MONTICELLO NUCLEAR GENERATING PLANT  
Docket No. 50-263 License No. DPR-22

Response to 2/4/76 Questions on MSL Setpoints and MCPR

SCRAM REACTIVITY FOR MONTICELLO CYCLE 5

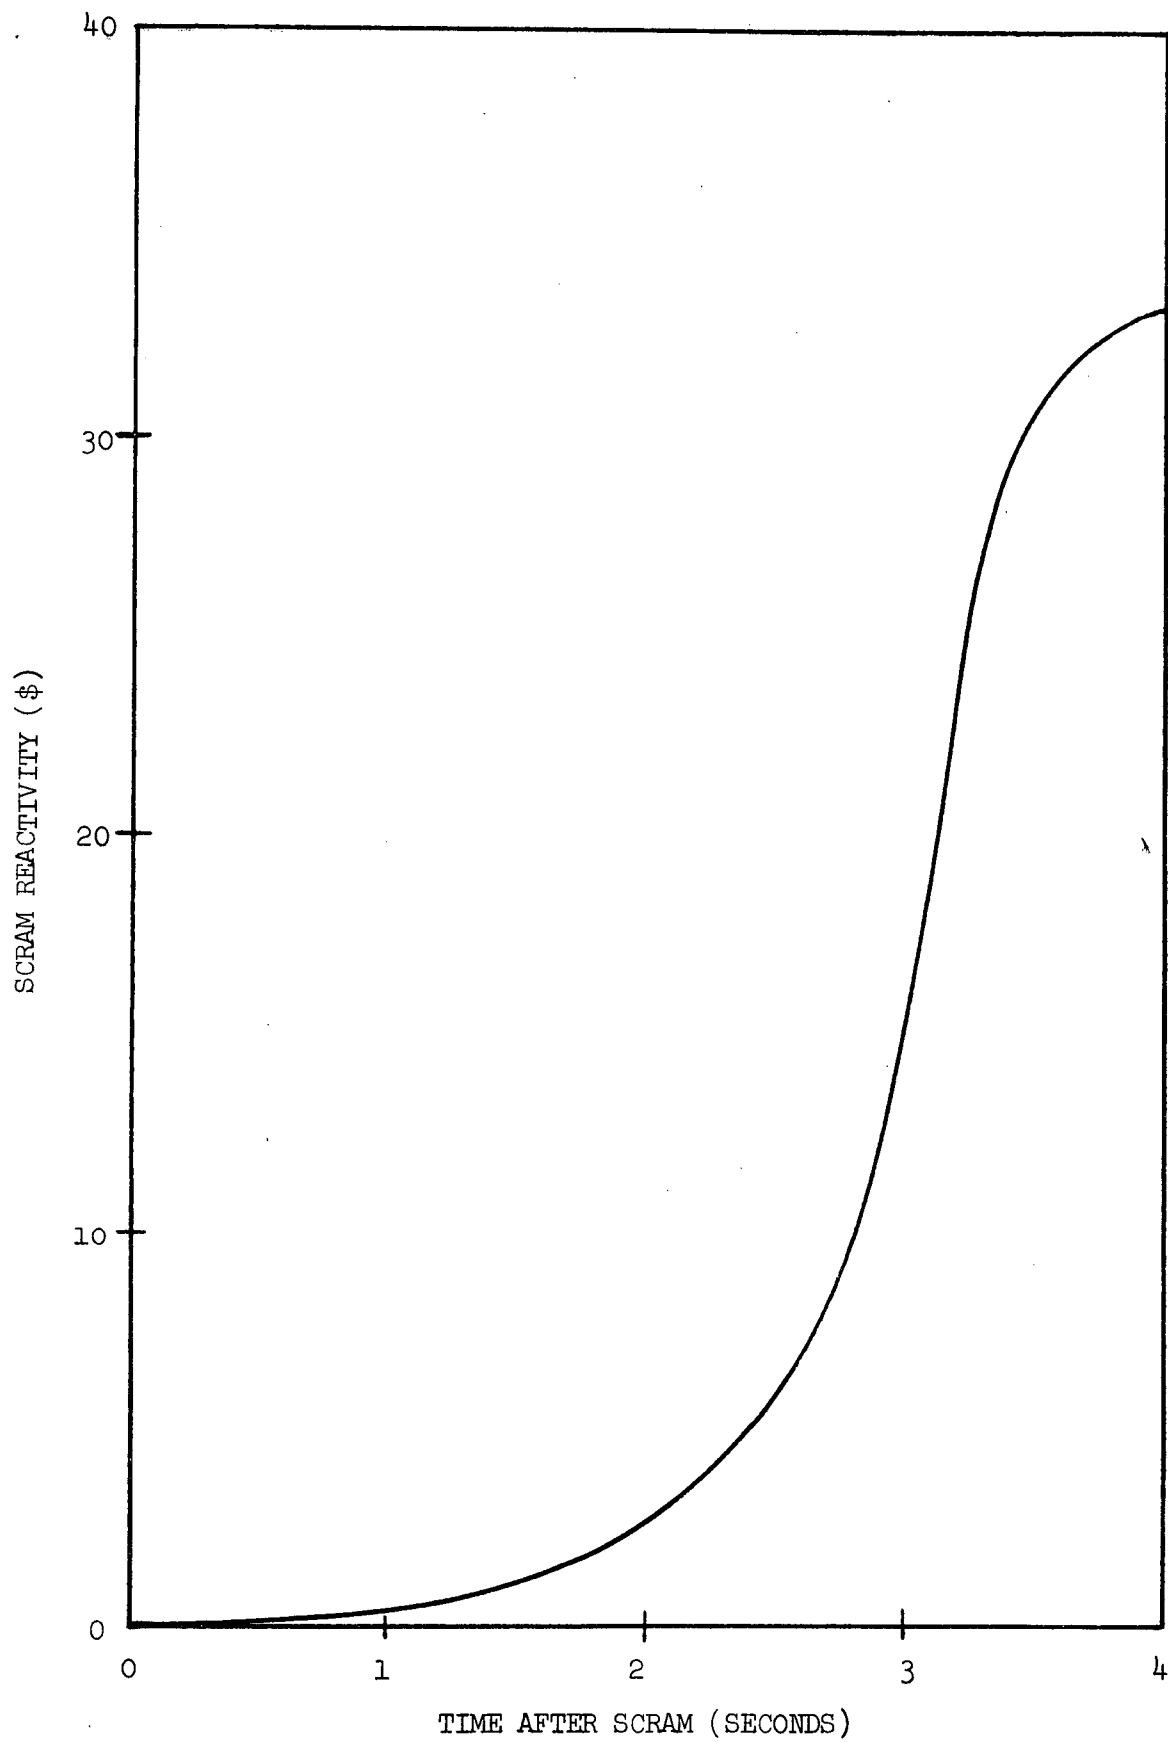
Provide the scram reactivity curve for EOC5.

The attached figure shows the scram reactivity used in the Cycle 5 analyses. This is conservatively derated to 80% of the expected value.
